# ADDENDUM No. 2: November 15, 2018

**PROJECT:** **Saint John the Baptist**
**Westbank Public Safety Complex**
**PROJECT NO.:** **STBA 21238.00**

**FROM:** SIZELER THOMPSON BROWN ARCHITECTS
300 Lafayette Street, Suite 200
New Orleans, Louisiana 70130
(504) 523-6472

1 DISPATCH ROOM 105
A201 | A801 3/8" = 1'-0"

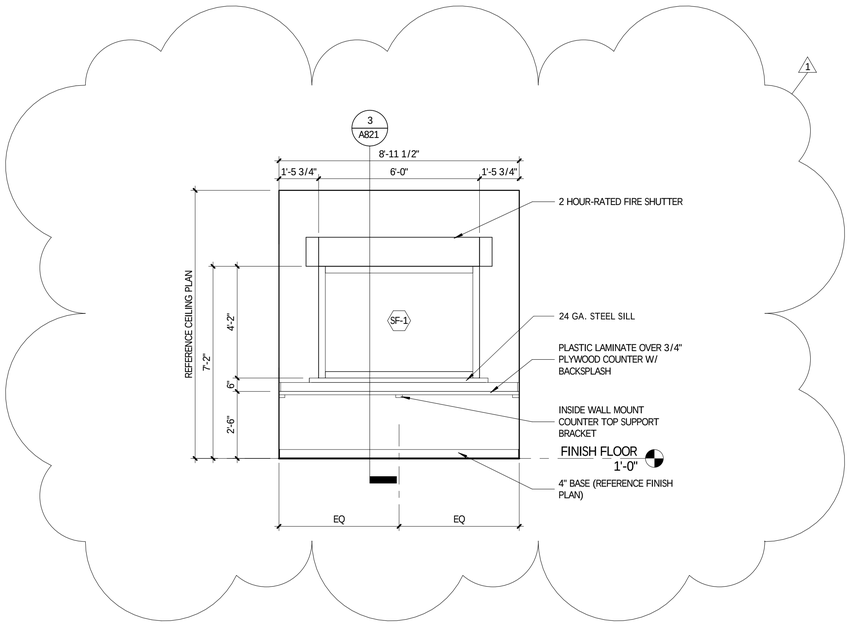
**13. <u>Sheet A801 Interior Elevations</u>**

Revised dispatch window size and head height.

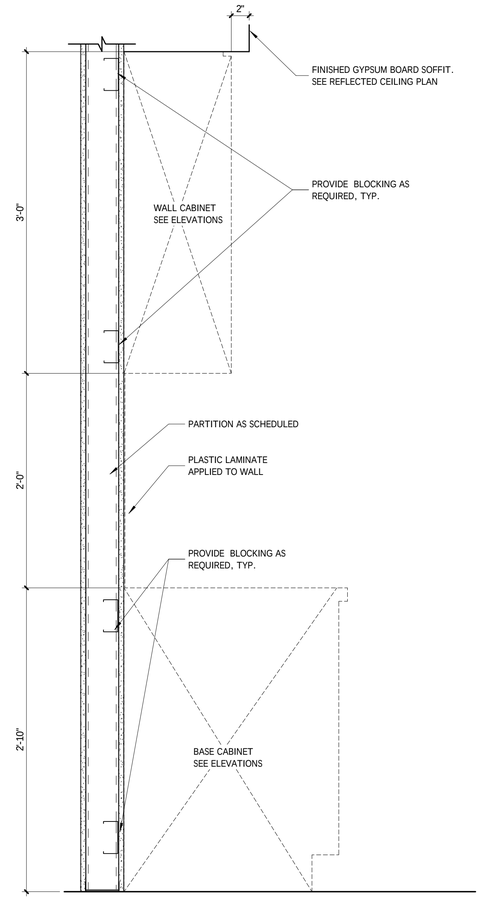
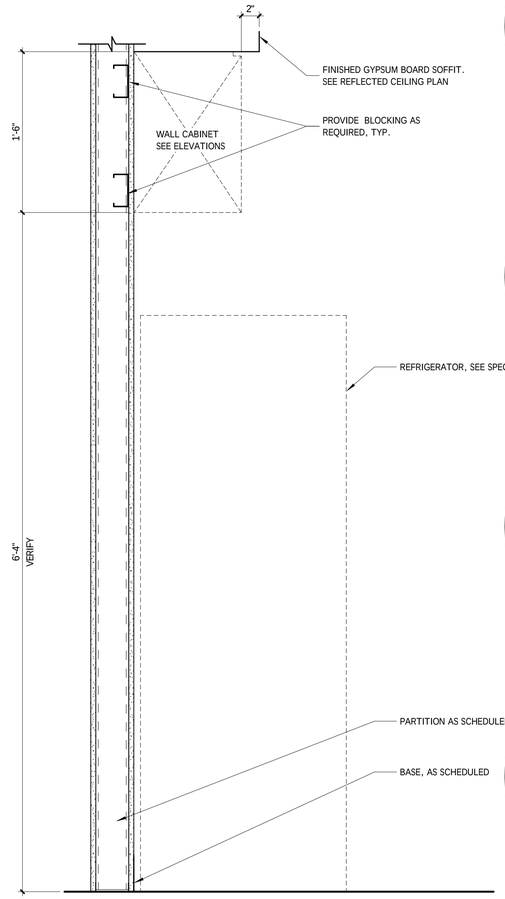
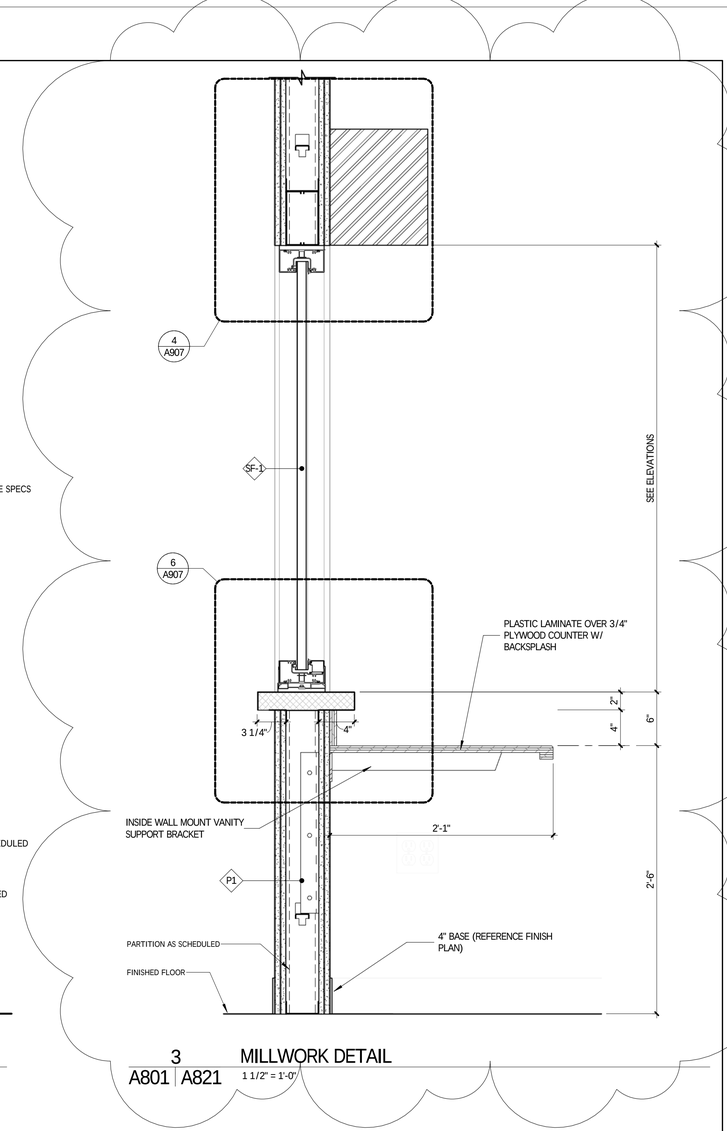
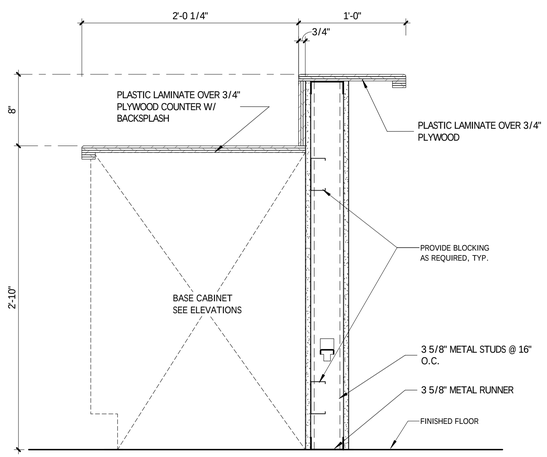
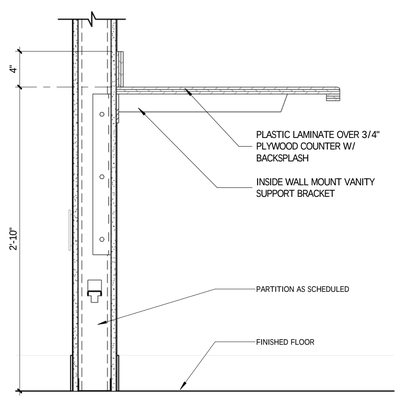
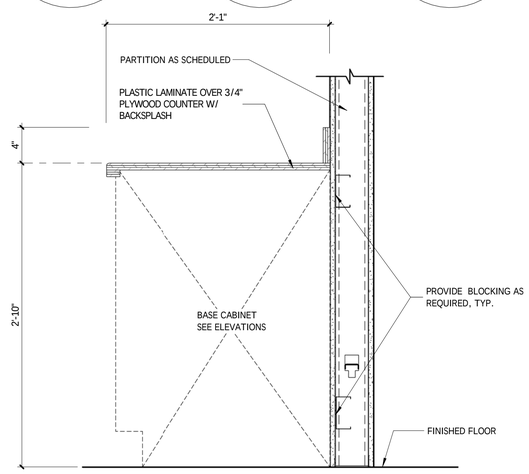
**14. <u>Sheet A821 Millwork Details</u>**

Revised this drawing where indicated by the clouds.

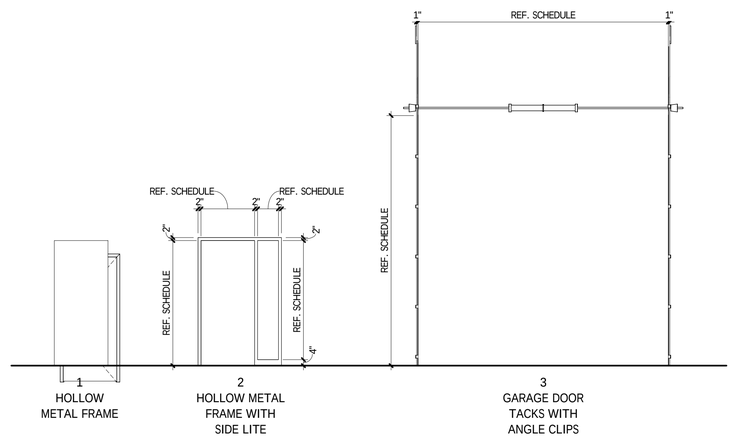
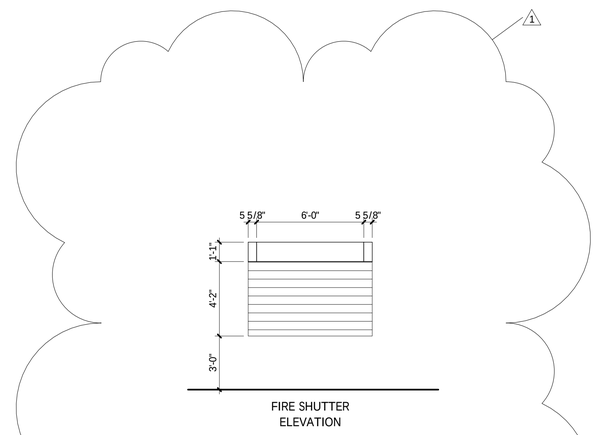
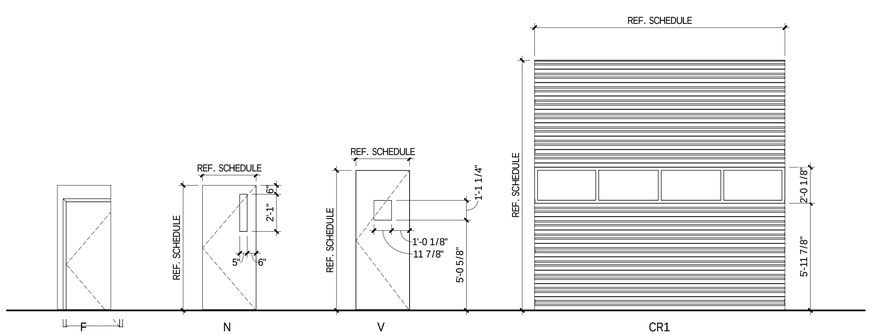
**15. <u>Sheet A903 Schedules (Doors and Windows)</u>**

Revise Door Schedule and Fire Shutter Elevation.

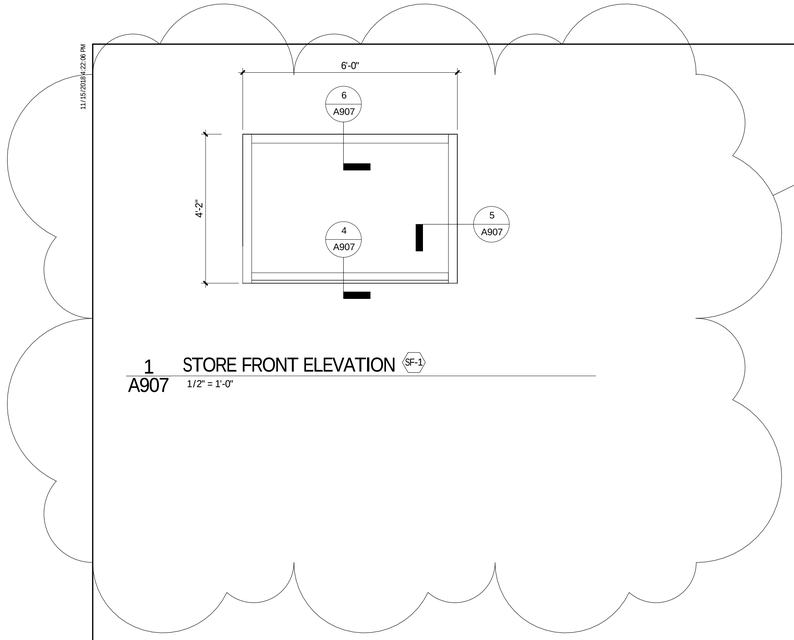
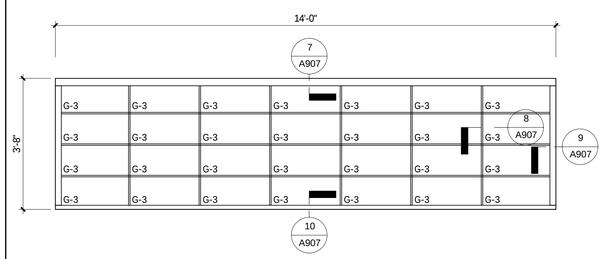
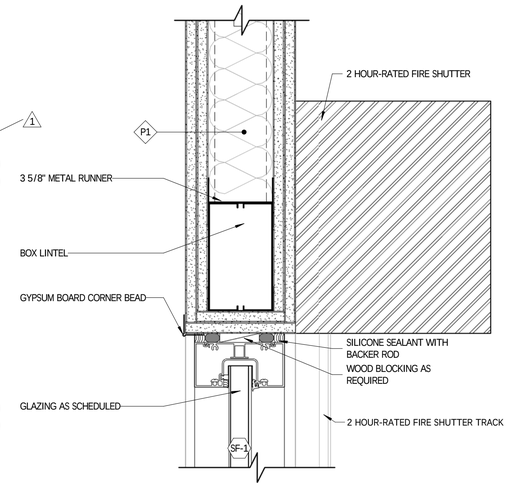
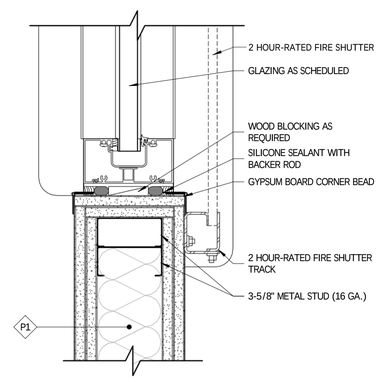
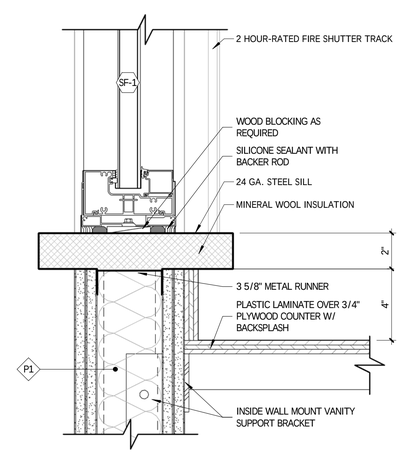
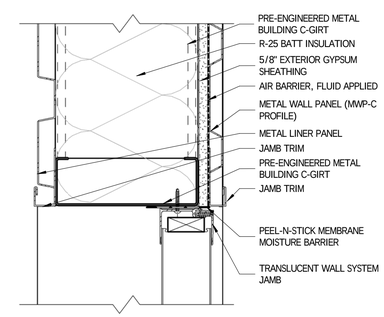
**16. <u>Sheet A907 Window Details</u>**

Revise this drawing where indicated by the clouds.

1 M201 HVAC PLAN
1/8" = 1'-0"

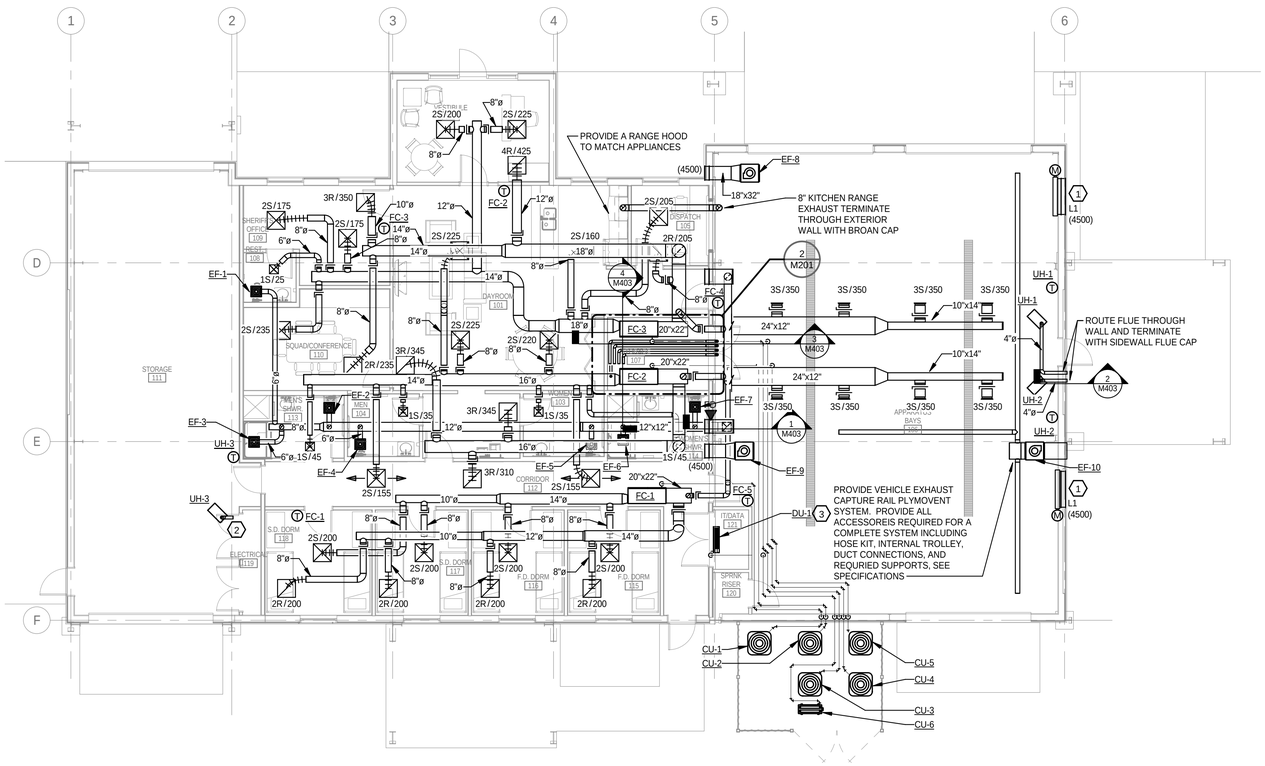
**17. <u>Sheet M201 Mechanical Plan</u>**

Added second set of intake and exhaust for additional tankless water heater.

1
P201

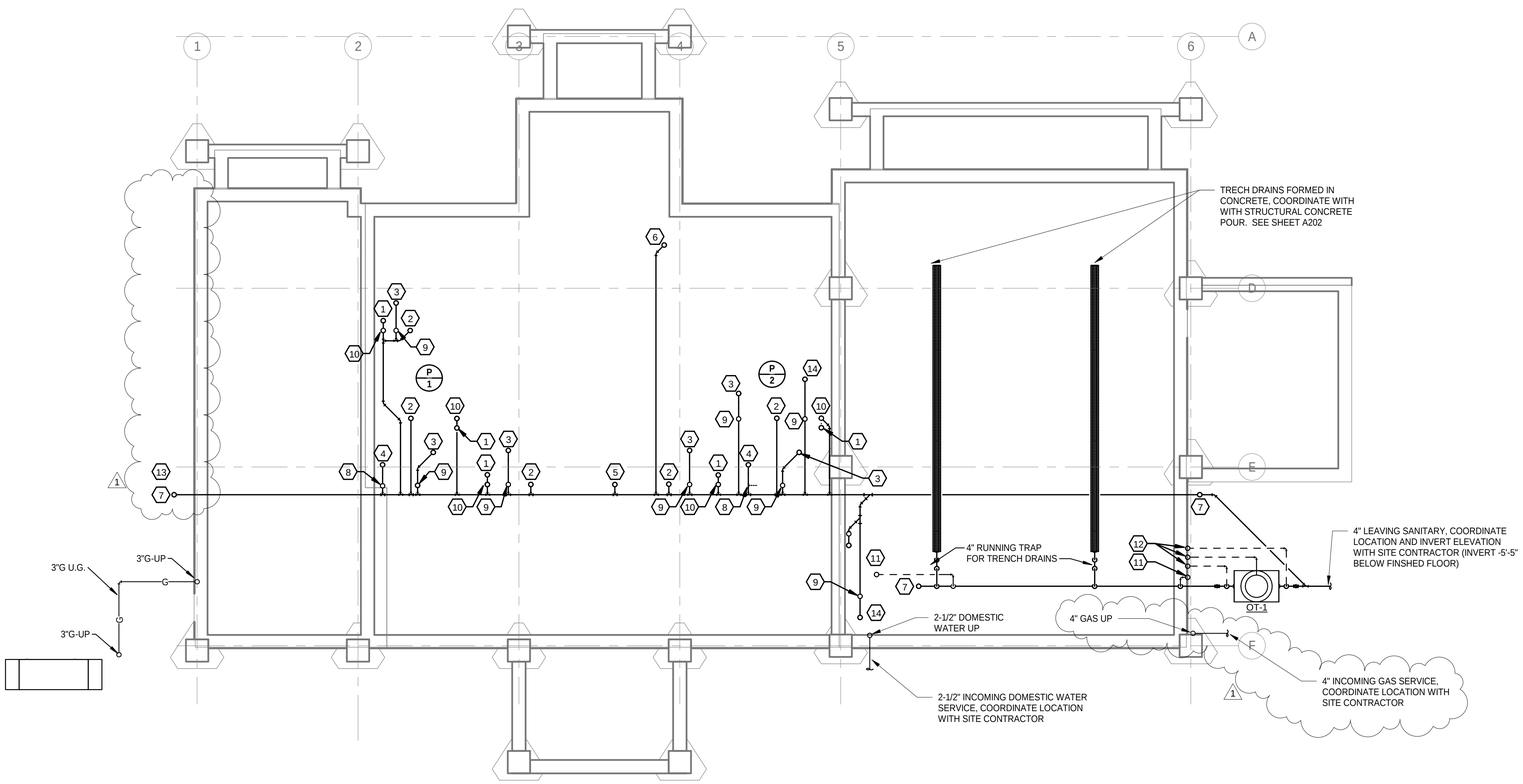
**19. <u>Sheet P201 Underground Plumbing Plan</u>**

a. Removed drain for RV.
b. Moved building end cleanout.
c. Added note referring to concrete pad around cleanout.
d. Changed incoming gas size to reflect load increase for tankless water heaters.

1
P202

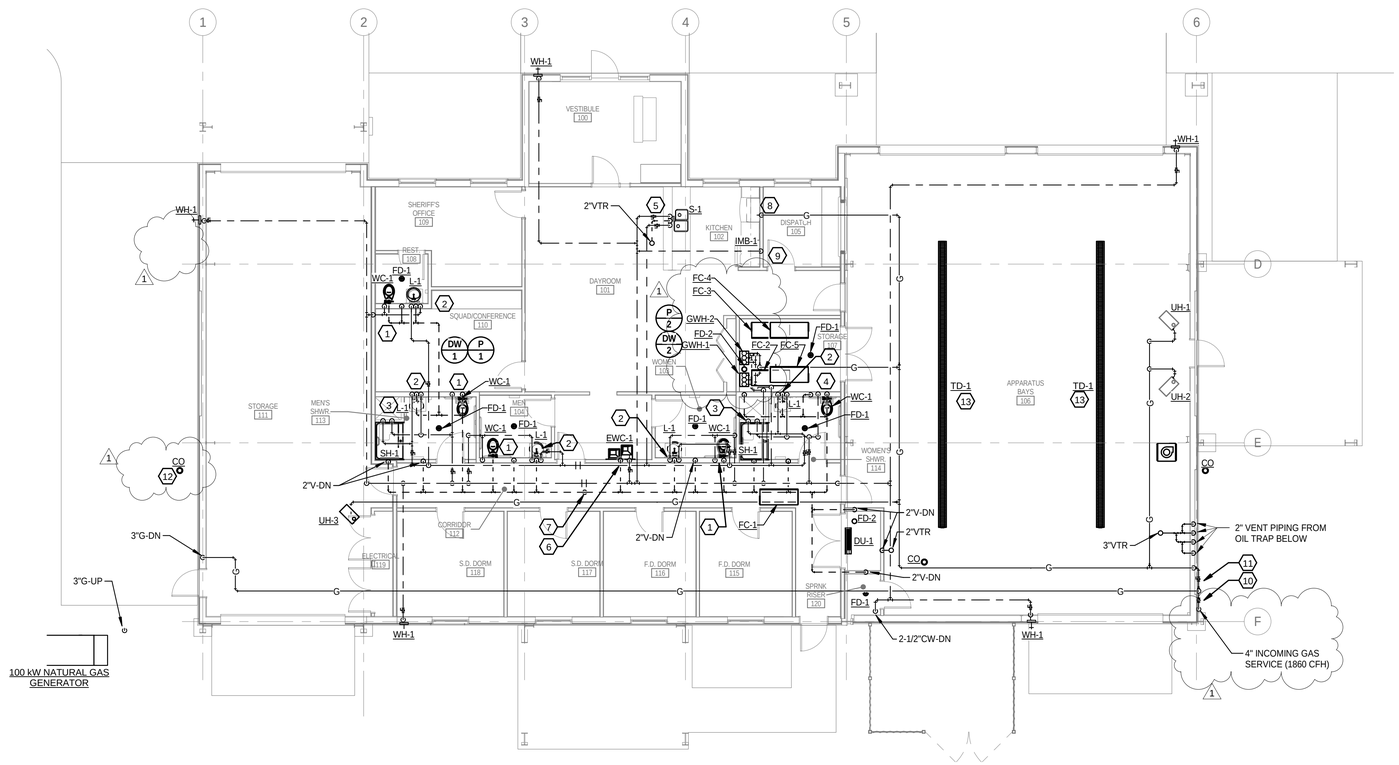
**20. <u>Sheet P202 Plumbing Plan</u>**

c. Added note referring to concrete pad around cleanout.
d. Changed incoming gas size to reflect load increase for tankless water heaters.
e. Added second water heater due to change from tank type to tankless water heaters

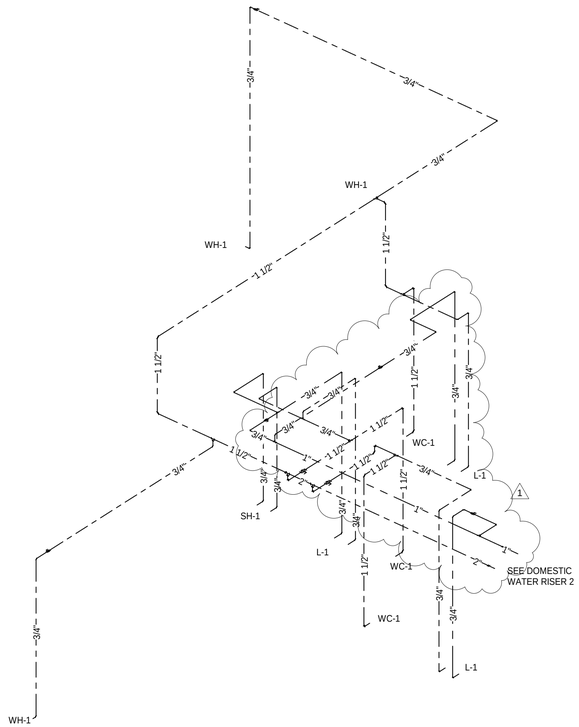
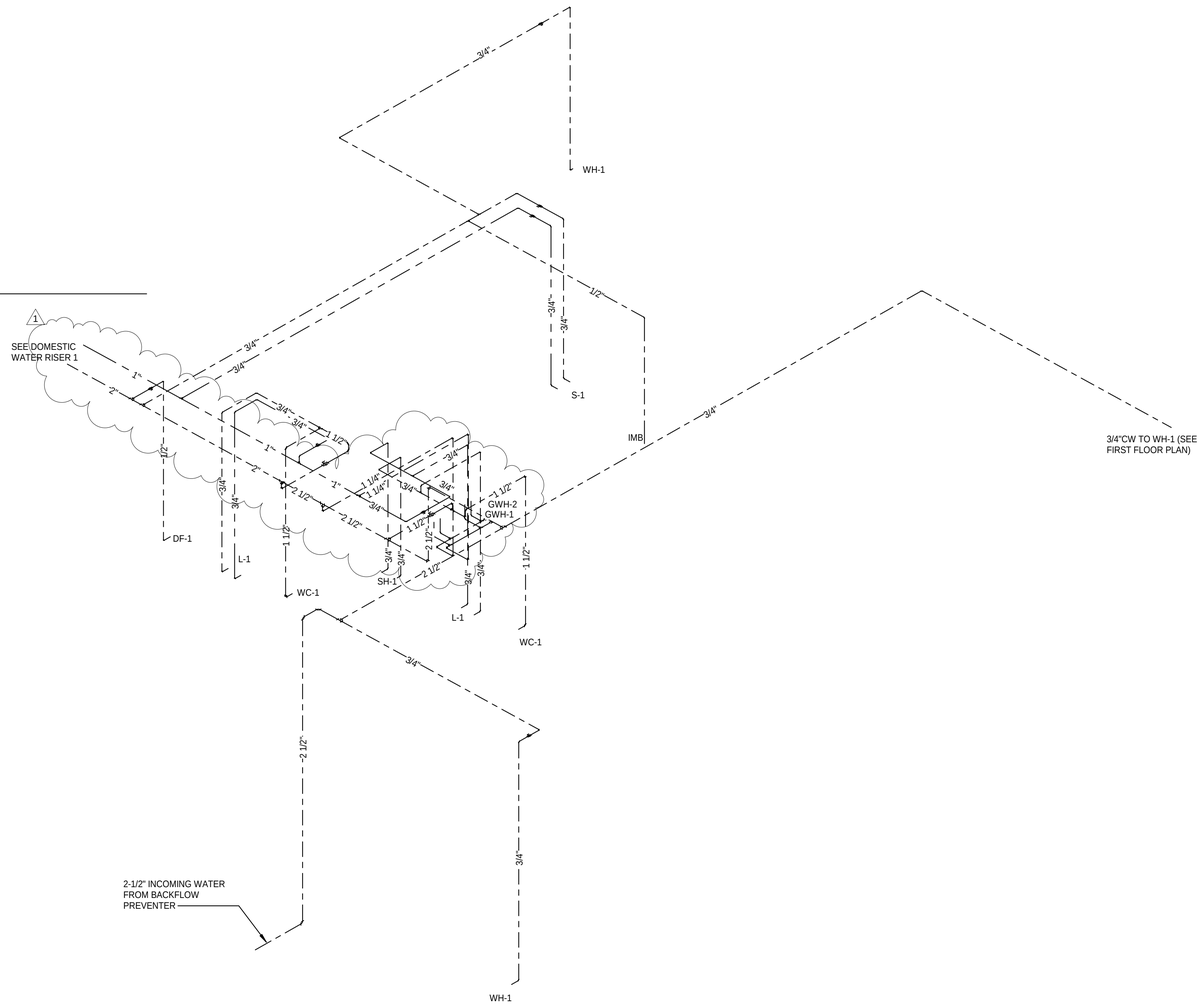
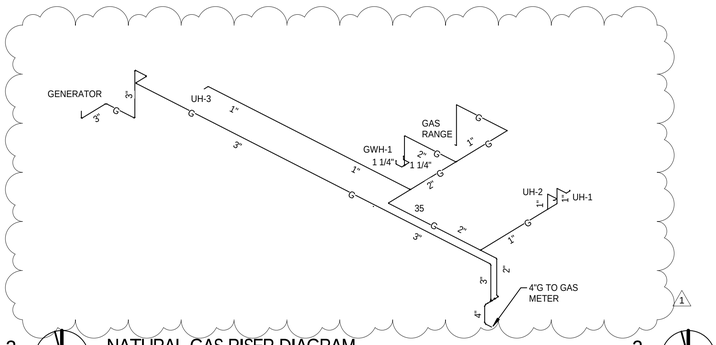
**21. <u>Sheet P401 Riser Diagrams – Domestic Water & Natural Gas Diagram</u>**

a. Removed hot water return pump and piping.
b. Changed gas sizes due to change from tank type water heater to tankless water heaters.
